**NORTH TUNCURRY
LOWER WALLAMBA RIVER
FLOOD STUDY**

23 April 2014

Re: Clarifications regarding August 2010 Wallamba River Flood Study

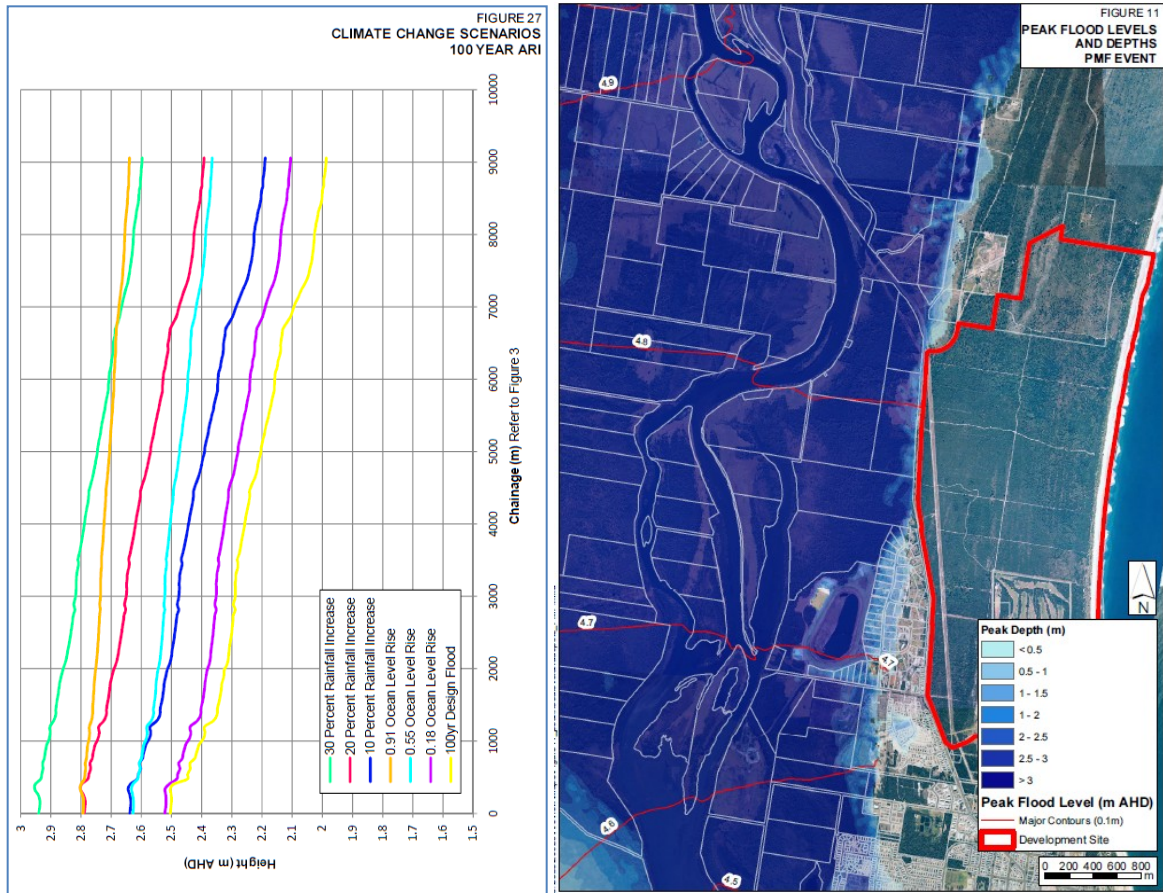
5. The analysis on sea level rise in the August 2010 report was undertaken for the 100 year ARI event only. However all design flood events will be affected by sea level rise. The magnitude of the increase in flood level caused by sea level rise diminishes with distance from the ocean (as shown in Figure 27 - copy below). At Chainage 9000 the increase due to a 0.91m sea level rise is approximately 0.65m, at Chainage 6000 (Tuncurry golf course) the increase is 0.55m and at Chainage 0 it is 0.3m. In larger floods than the 100 year ARI the increase due to sea level rise will diminish more rapidly with distance. In a 200 year ARI event the increase in flood level due to a 0.91m sea level rise will still not increase flood levels sufficient to cause flooding within the study area. In the Probable Maximum Flood (PMF) an indicative flood level adjacent to the study area is from 4.6 m to

4.8 mAHD (Figure 11 - copy below) and does not cause flooding within the study area. No modelling has been undertaken for a 0.91m sea level rise in the PMF but based on the data available this will still not produce flooding within the study area.
